**STAFF REPORT AND RECOMMENDATION TO THE HISTORIC LANDMARKS COMMISSION**

**CASE FILE:** LU 15-268017 HRM AD – 221 SW Naito  
PC # 15-261483

The applicant proposes a new 6-story vacation ownership (hotel) building in the Skidmore/Old Town Historic District to replace an existing surface parking lot. The maximum FAR allowed on the site is 4:1. Additional 0.92:1 FAR is to be gained through eco-roof bonus for a total 4.92:1 FAR. Proposed exterior materials include brick, precast concrete, aluminum storefront, vinyl windows and doors, steel and iron railings, metal banding and cornice, metal mechanical enclosure, a glass & steel canopy and fabric awnings.

DESIGN REVIEW 15-268017 C15

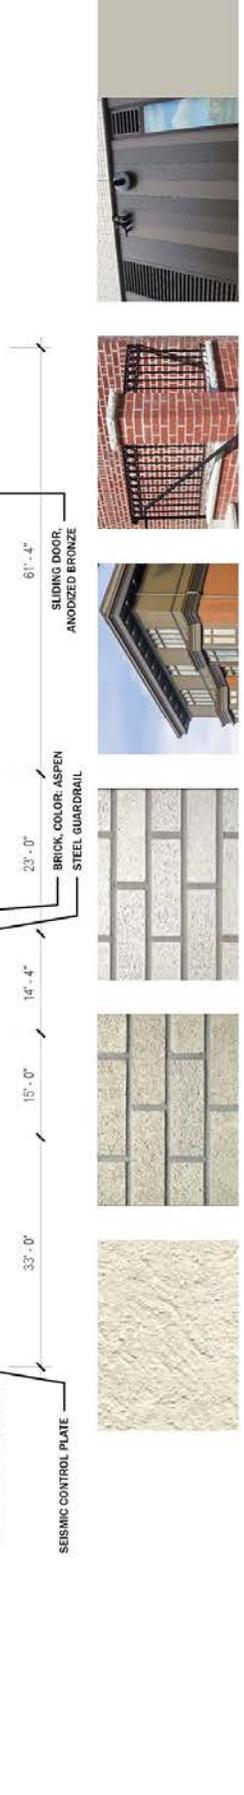
The Portland Zoning Code requires that 25% of the area and 50% of the length of ground floor walls be windows or doors into active areas. The applicant meets the 25% area requirements on both façades; however windows only make up 48% and 24.8% of the ground floor wall area on SW Naito and SW Pine, respectively; therefore, the applicant is requesting a Modification to this standard which is further discussed below. Because the proposal does not provide the minimum required amount of windows at the ground level, staff cannot confidently state that this guideline is met, particularly since there appear to be no significant (structural) impediments to the provision of this requirement, particularly along SW Naito; the only impediment to the this standard and guideline being met is the chosen style of architecture. As has been noted, a more cast iron character, particularly at the ground floor would not only be responsive to the Commission's prior comments but would also meet the ground floor windows standard along SW Naito and allow more views between the interior and exterior.

**Findings:** The applicant requests a Modification to the ground floor active use standard as this standard is not met along SW Pine Street, where the interior active use spaces equal 47% of the ground floor frontage, as opposed to the required 50%. The 47% of active floor area includes a guest library, front desk, guest supply store, and offices and ends at the proposed generator room. As is noted above, staff has previously suggested that the generator be relocated so that it is not located at the street edge of the building; likewise, the water service room should also be relocated away from the building edge. Staff has also previously noted that two egress passages are located west of the generator room, resulting in a redundancy and adding to the total amount of inactive spaces along this frontage. Considering that the proposal is 3% shy of meeting the standard, with relocation of the generator and water service rooms and consolidation of the egress passages, this standard may be able to be met.

***These guidelines are not yet met; however with expansion of the ground level windows, these guidelines could be met.***

DESIGN REVIEW 15-268017 C21

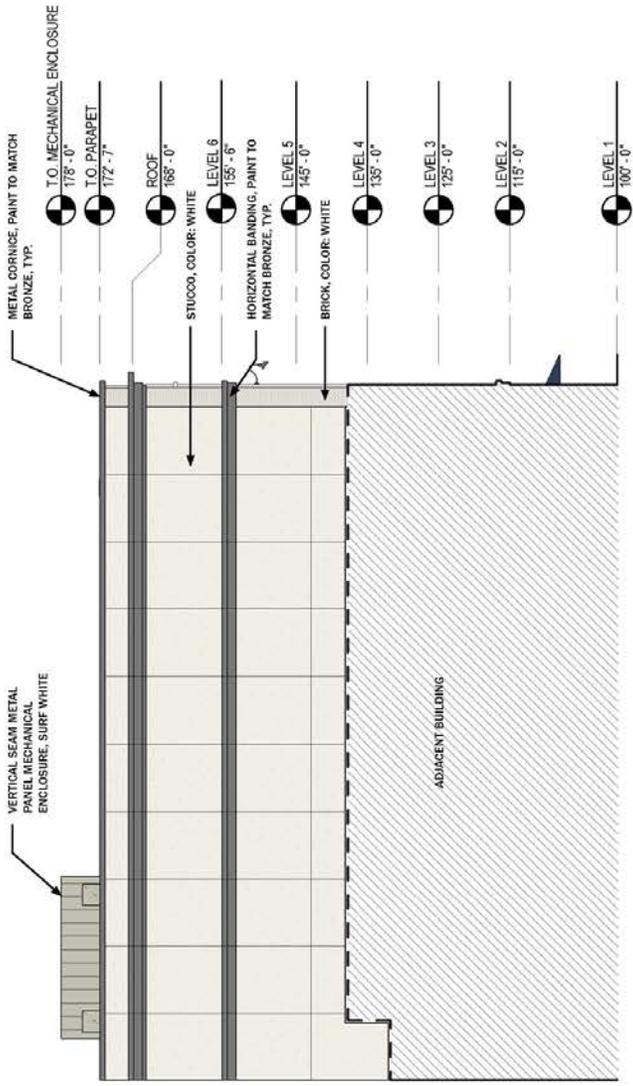
**Findings:** The building is proposed to be clad with a standard brick veneer on the street-facing and south and east courtyard façades with stucco proposed at the south and west façades, as well as the north and west façades of the courtyard. The brick and mortar joints appear to be of standard dimension of 4 bricks to a vertical 1'-0". The proposed color for both the brick and stucco is white, with some of the brick shown to be a very light tan. The Color Guideline for Alterations and Additions, referenced above, is copied here:

While this guideline suggests that white was rarely used, this portion of the guideline appears to reference colors which were applied, such as paint. With regard to permanent materials and colors, it states that earth tones, including beige were used during the era of the historic district. Staff notes that there are buildings in the district that are shades of white and the adjacent buildings are currently shades of white or off-white. As such, the proposed brick colors may help the proposed building integrate with the adjacent buildings, depending on the qualities (texture, light refraction/absorption) of the actual brick proposed; staff suggests that the brick should be of a matte, rather than glossy finish.

DESIGN REVIEW 15-268017 C22

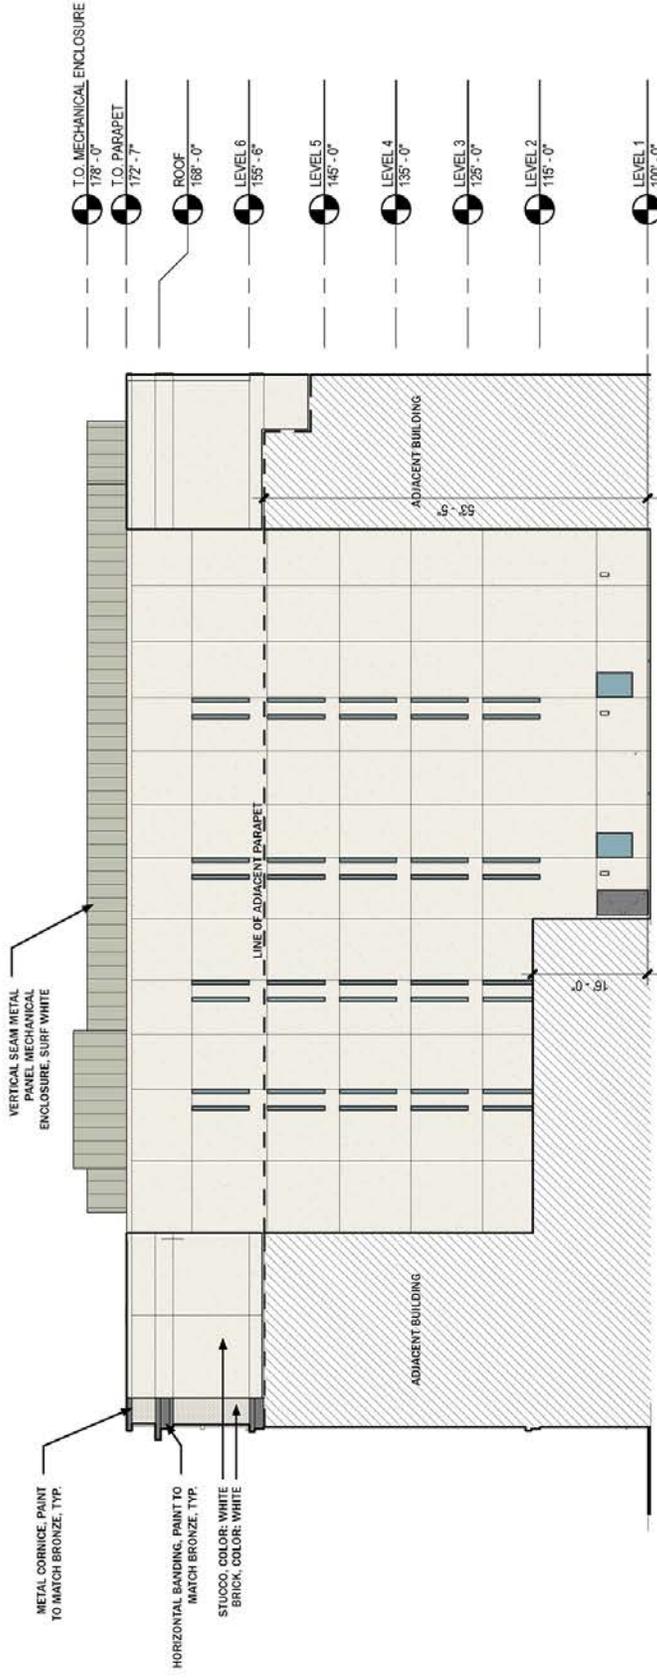
**Findings:** At the Design Advice Request, the commission suggested that the sides and rear of the building, including within the courtyard should be more subdued than the street-facing façades, noting that at that time the courtyard façades were equally articulated, reinforcing the appearance of a single building rather than a grouping of buildings. Staff notes that in the current proposal, the front portion of the courtyard, as well as the full south façade of the courtyard is articulated in the same manner as the street-facing façades, with brick detailing and pilaster articulation. However, the west and north façades of the courtyard are stripped of ornament and clad in stucco. The south and west walls of the building are much more subdued, featuring stucco panels with a slight brick wrap at the street edges, and the west wall features a series of vinyl windows at the interior corridor, each rather prison-like at less than 1'-0" wide.

While the Commission previously suggested less articulation at the courtyard, as noted above, the proposed stripped down stucco façades in the courtyard present a relatively stark and unpleasant contrast to the more articulated façades. Staff supports the articulation of the brick courtyard façades and suggests that this treatment, or some variation of this articulation, be continued along the west and north façades of the courtyard, particularly the west which is visible from the street. Staff also suggests the removal of the western narrow windows as they serve essentially no purpose and will only increase the likelihood of water infiltration, particularly since they are proposed to be flush, or even proud, of the exterior stucco as is shown on C44.

***This guideline is not met; however, with additional consideration of the west and north courtyard façades and removal of the west façade windows, this guideline could be met.***
